Title: **QUALITY AUDIT**

**Stage 1 Road Safety Audit, Access Audit, Cycle Audit,
Walking Audit & Non Motorised User Audit.**

Public Realm Improvements for a Pedestrianised New Street

Report reference: **1652R01**

Drawing 222126-PUNCH-XX-XX-DR-C-0450 P01, Pedestrian crossing at southern end of New Street.

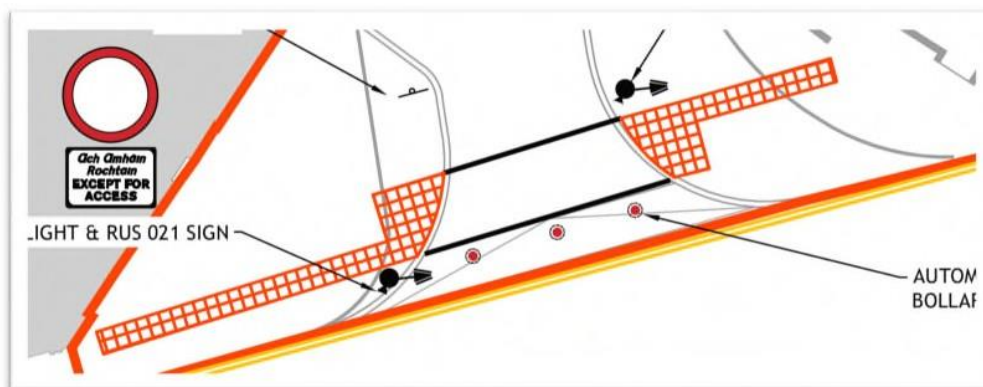
It is proposed to provide a signalised controlled pedestrian crossing at the top of New Street. Access to the street is to be very restricted for vehicles and when the bollards are up pedestrians will not need signal control. It is felt by the Audit Team that the signals may not be required and if provided will be mainly ignored by pedestrians.

It is recommended that the need for signals be assessed and the possibility of a courtesy crossing system be provided whereby vehicles will wait for a gap in pedestrian activity to cross and that the bollards movement will signal the upcoming hazard for pedestrians.

3.1	Yes	Yes		
3.2	No	No	<p>The section of New Street between The Diamond and Ross Cottages will be designated as a Destination Street (a node), and not a cycling street. Cyclists utilising the pedestrianised section of New Street will need to dismount. This is in line with the modal hierarchy and Active Travel principles.</p> <p>In accordance with the Fingal Development Plan 2017-2023, cyclist access to the Dart Station from New Street is to be facilitated via westbound on the Strand, southbound along Old Street and westward on Railway Avenue.</p>	Yes

Drawing Fc.03-DR-2001 Rev B DFLA, Specimen Tree.

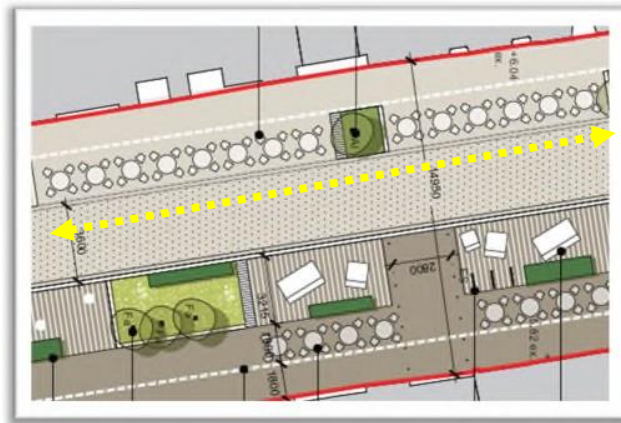
It is proposed to provide a specimen tree at either end of the street. There is a risk that the northern tree could block a drivers visibility of the traffic signal head. This could result in collisions with crossing pedestrians.

It is recommended that the tree and signal pole be located where visual obstruction to the signal head does not occur.

3.3	No	No	<p>The proposed location of the signal head is north of the pedestrian crossing point, remote from the proposed specimen tree. The proposed specimen tree is 'Pinus Sylvestris' and the associated foliage is not anticipated to obscure the visibility of the signal head to road users.</p> <p>Furthermore, there is an additional signal head at the other side of the junction to provide further guidance to traffic.</p>	Yes

Drawing 222126-PUNCH-XX-XX-DR-C-0550 P01, Dropped kerbs

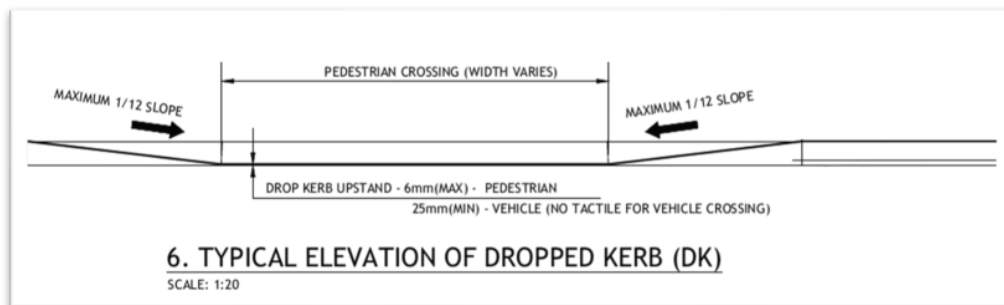
There is a relatively steep longitudinal fall on New Street. At proposed dropped kerb locations there could be a compound gradient which may lead to inaccessibility for some mobility impaired users.

It is recommended that shallower gradients be used where there is an existing longfall to avoid a cumulative gradient effect or that the alternative of raised or partially crossings be provided.

3.4	Yes	Yes		
3.5	Yes	No	The only dropped kerb locations are at the pedestrian crossings at the extreme northern and southern	Yes

<p>extents of New Street. These locations (particularly the northern end) coincide with flat topography and are unaffected by the compound gradient effect outlined in the audit observation.</p> <p>Particular attention will be brought to the detailed design of these dropped kerb locations to ensure that the issue of compound gradient does not adversely impact on accessibility.</p>	
3.6	Yes	Yes		
3.7	No	No	<p>This right turning facility will remain in place to facilitate delivery vehicles between 07:00 and 11:00 each day approaching the Diamond junction from the east.</p>	Yes
3.8	Yes	Yes	<p>Each threshold will be examined at detail design stage to review if improved access can be provided.</p>	Yes
